## PHASE 2 - WESLEY BRADLEY PARK

EXISTING SITE AND TESC PLAN NORTH  
FOR  
CIVIL PLANS  
PHASE 2 - WESLEY BRADLEY PARK

Job Number  
16718  
Sheet  
C2 of 19

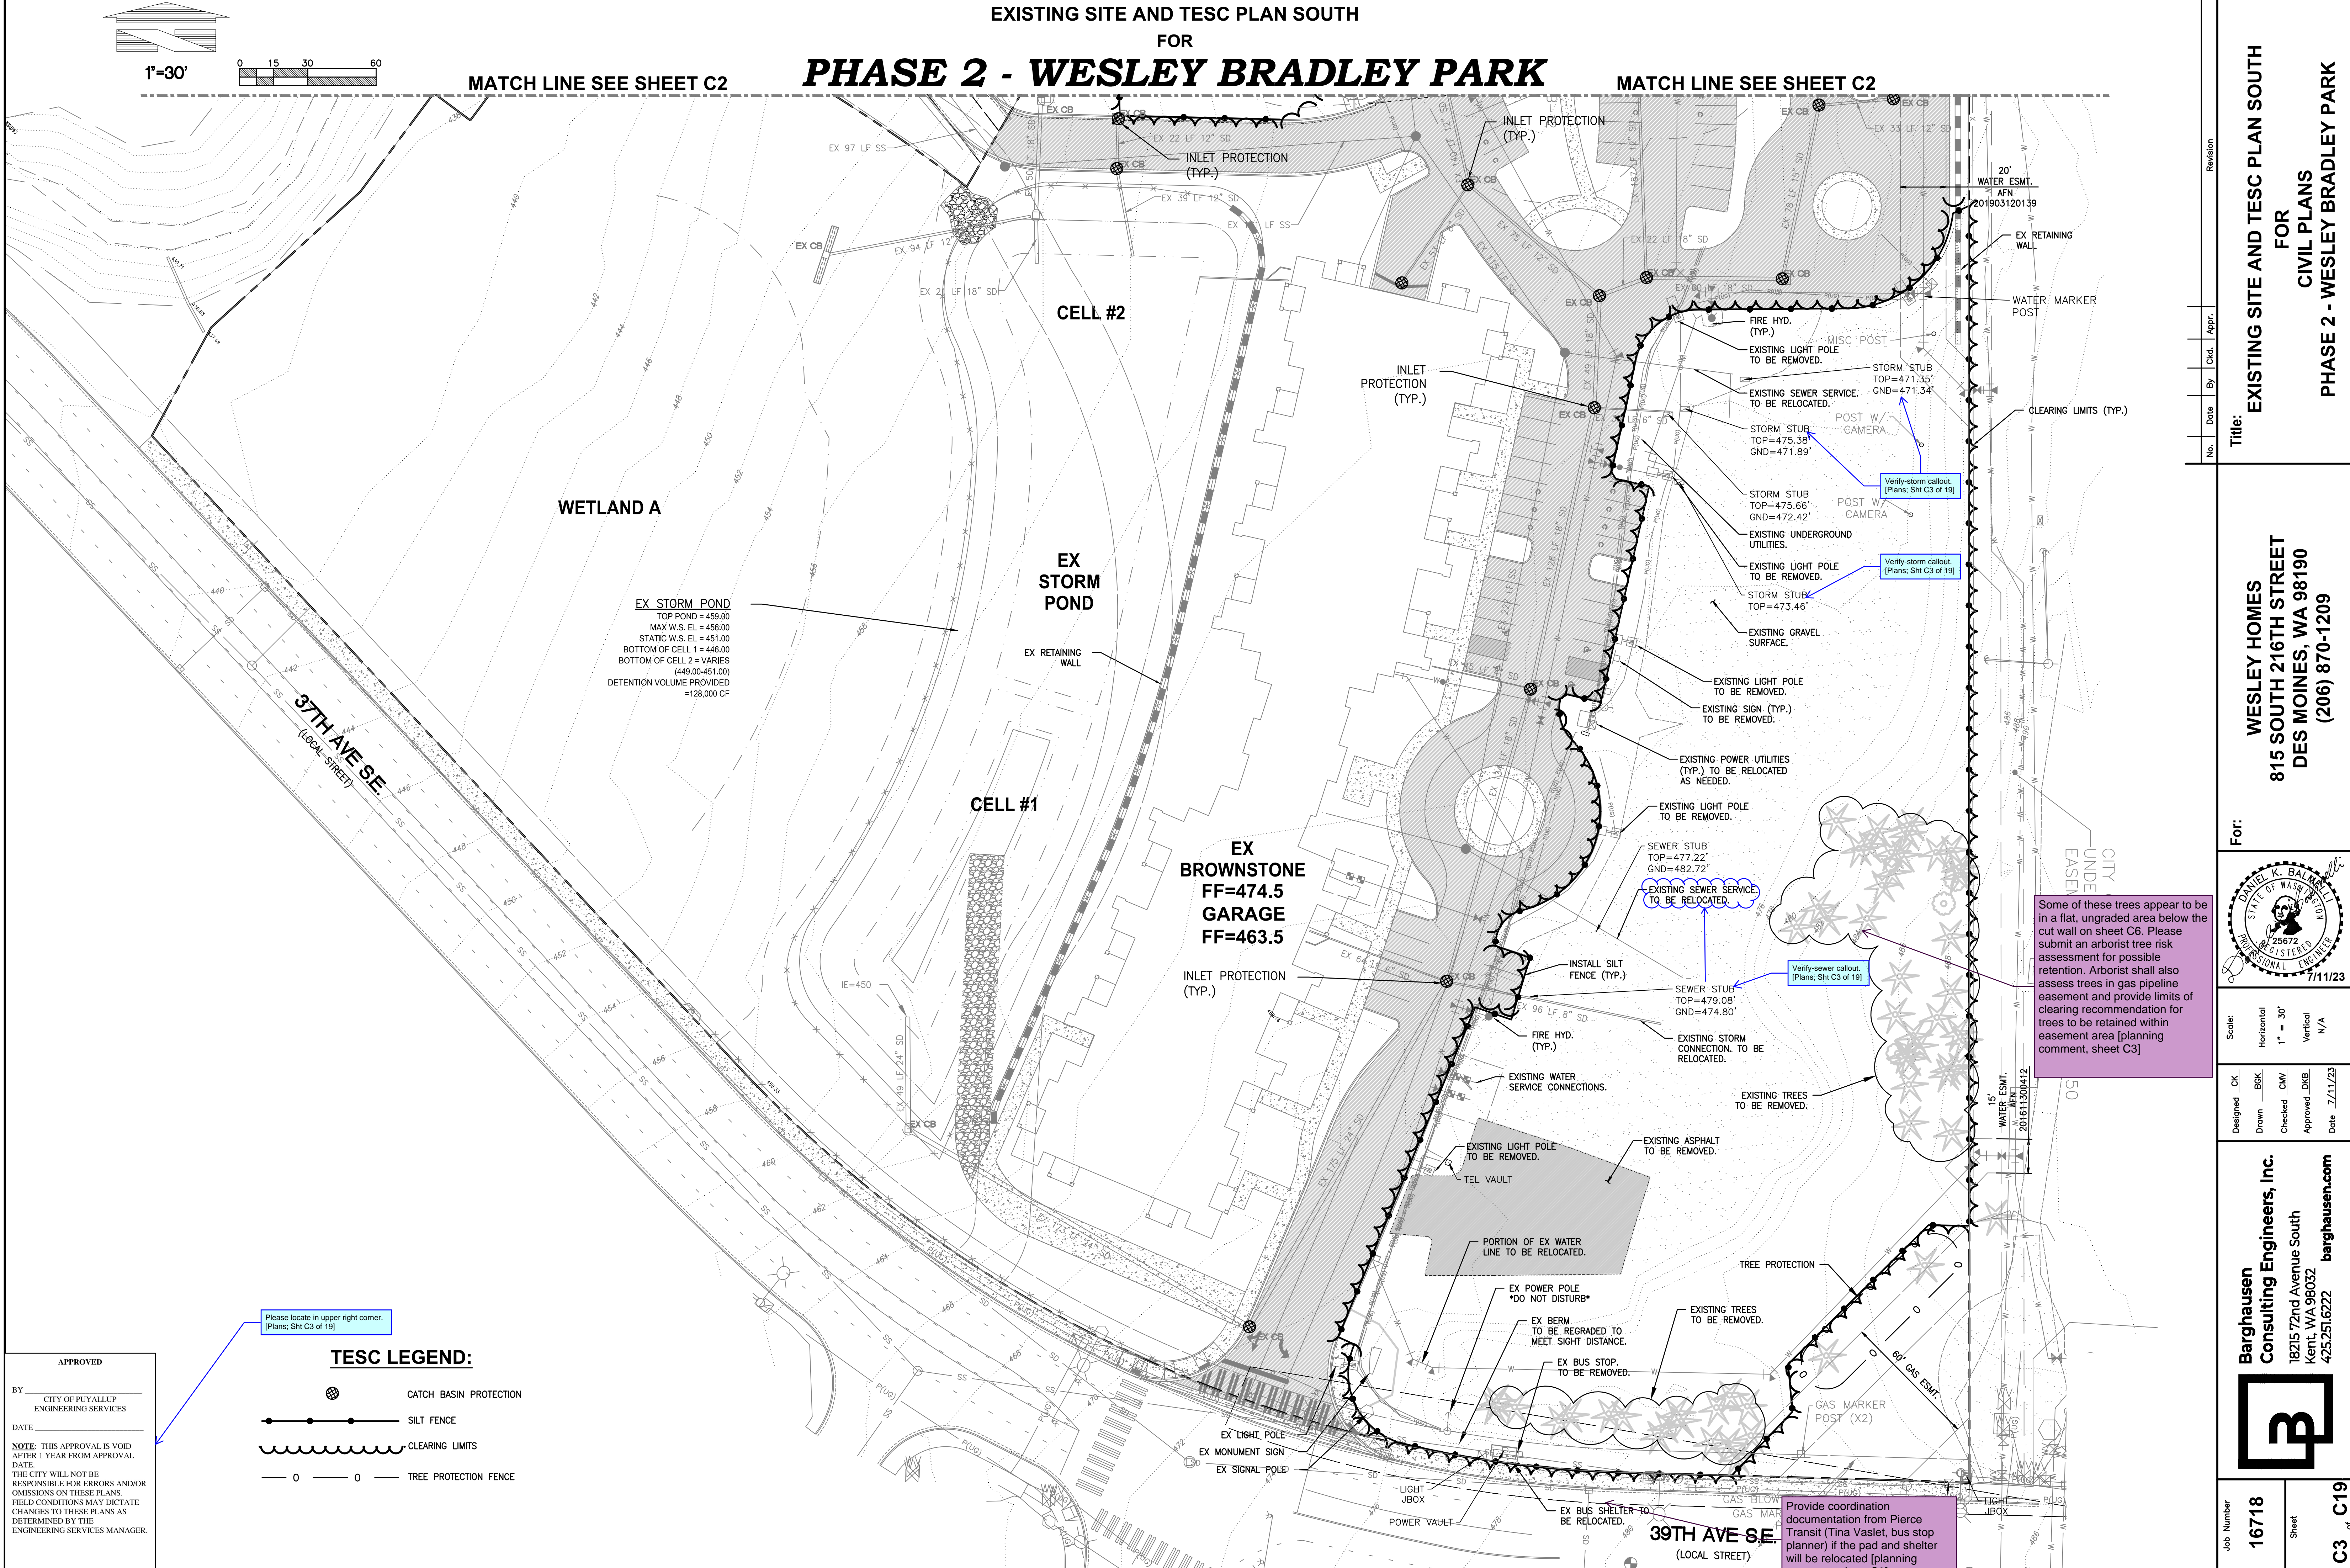
Some of these trees appear to be in a flat, ungraded area below the cut wall on sheet C6. Please submit an arborist tree risk assessment for possible retention. Arborist shall also assess trees in gas pipeline easement and provide limits of clearing recommendation for trees to be retained within easement area [planning comment, sheet C3]

Provide coordination documentation from Pierce Transit (Tina Vaslet, bus stop planner) if the pad and shelter will be relocated [planning comment, sheet C3]

**GRADING PLAN NORTH  
FOR  
CIVIL PLANS  
PHASE 2 - WESLEY BRADLEY**

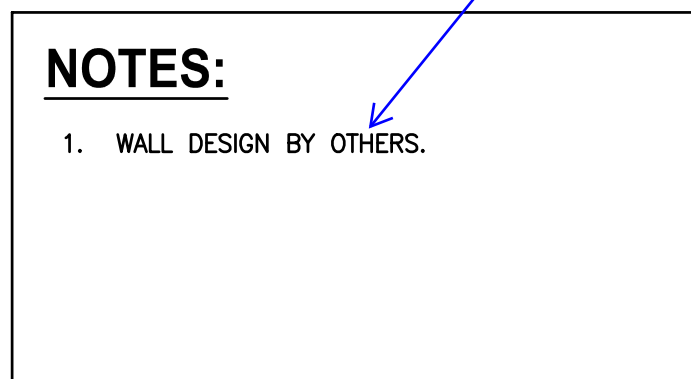
Prior to permit issuance, provide letter or statement from the retaining wall EOR that the west wall design includes an evaluation of potential surcharge loading from the adjacent building.  
[Plans; Sht C5 of 19]

Clarify-Do not find this designation on the plan. Is this for a specific wall or all of the proposed walls.  
[Plans; Sht C5 of 19]

PMC 20.58.005 (2)  
requires a 6 foot  
landscape setback.  
The walkway and  
wall system appear  
to eliminate the buffer  
in this stretch.  
[Planning comment,  
sheet C5]

PMC 20.58.005 (2)(ii) requires retaining walls to set back minimum of 6 feet with a maximum of 6 feet in height. The wall is located in the six foot setback area and some areas of the wall exceed 6 feet in height [Planning comment, sheet C5]

GRADING PLAN SOUTH  
FOR  
**PHASE 2 - WESLEY BRADLEY PARK**

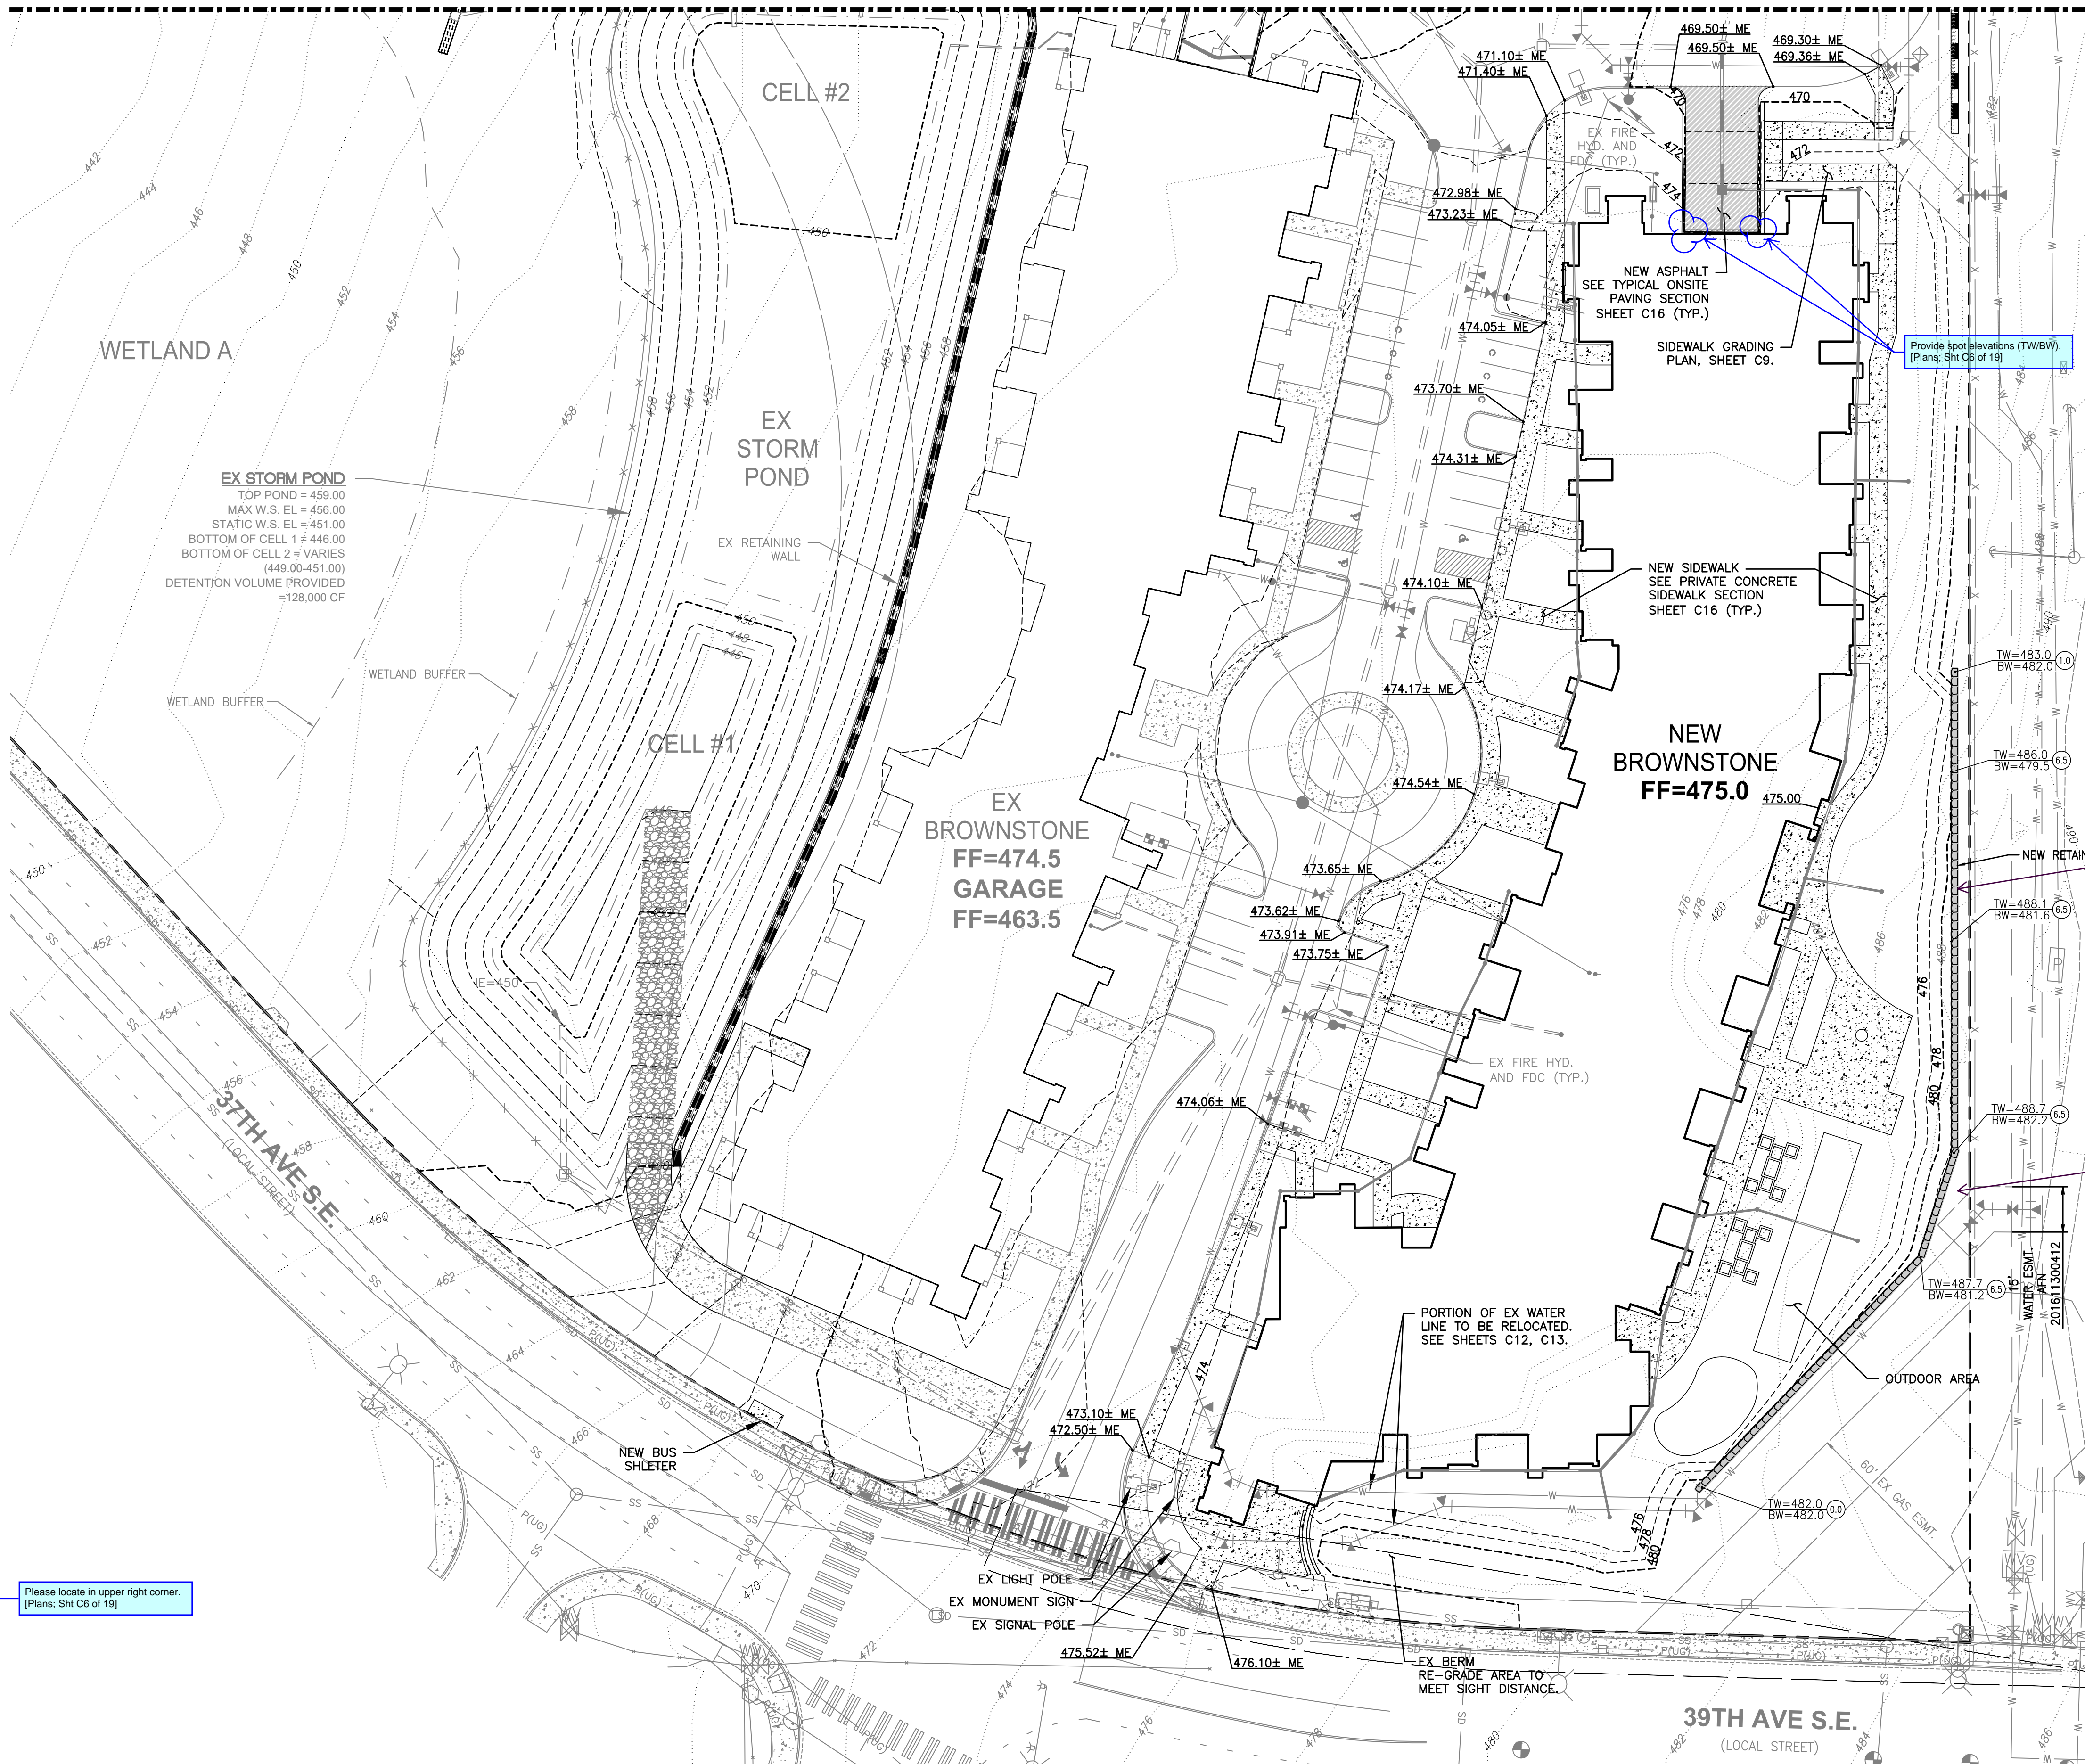
Wall near the brownstone structure is a cut wall (facing interior to site). PMC 20.58.005 (2)(ii) will not apply to this wall system. [Planning comment, sheet C6]

See PMC 20.58.005(2)(i) for retaining wall setback criteria. [Plans; Sht C6 of 19]

Note to Engr: Building Permit(s) required for any retaining wall over 4ft (bottom of footing-to-top of wall) or any retaining wall that is surcharged. [Plans; Sht C6 of 19]

Consider adjusting wall interior to the site to retain existing trees in this area. Project arborist to review plan sheet and coordinate with design to determine feasibility of tree retention [Planning comment, sheet C6]

Provide spot elevations (TW/BW).  
[Plans; Sht C6 of 19]

DRAINAGE PLAN NORTH  
FOR  
CIVIL PLANS  
PHASE 2 - WESLEY BRADLEY PARK

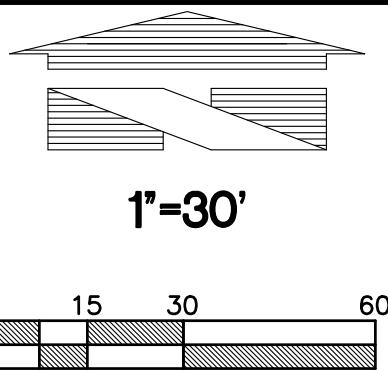
This roof area was not included in the original PH1 MR8 wetland analysis. If this PH2 roof area will direct discharge to the wetland as shown, provide an updated MR8 analysis to ensure the wetland is not compromised. Depending on the category and habitat score of the wetland, the project WWHM may have to be rerun to account for this roof area as bypass. [Plans; Sheet C10 of 19]

Remove note. [Plans; Sht C10 of 19]

Verify callout. [Plans; Sht C10 of 19]

Callout dimension(s) of dispersion trench. [Plans; Sht C10 of 19]

Callout size, length, and slope of pipe run. [Plans; Sht C10 of 19]

Callout dimension(s) of relocated dispersion trench. [Plans; Sht C10 of 19]

Show new pipe run and callout size, length, and slope. [Plans; Sht C10 of 19]

Callout Roof Drain IE at existing connection. [Plans; Sht C10 of 19]

Provide IE. [Plans; Sht C10 of 19]

Provide Trench Drain Rim Elev. [Plans; Sht C10 of 19]

Use DI due to shallow bury. [Plans; Sht C10 of 19]

Readability. [Plans; Sheet C10 of 19]

See comments on Sheet C7 for this raised parking area. [Plans; Sheet C10 of 19]

Per Phase 1 calculations, this Stormfilter was only sized to collect tributary runoff from the access road. Revise accordingly. See Ecology, Section III-2.6 regarding pollution generating and non-pollution generating runoff draining to a single treatment device. [Plans; Sheet C10 of 19]
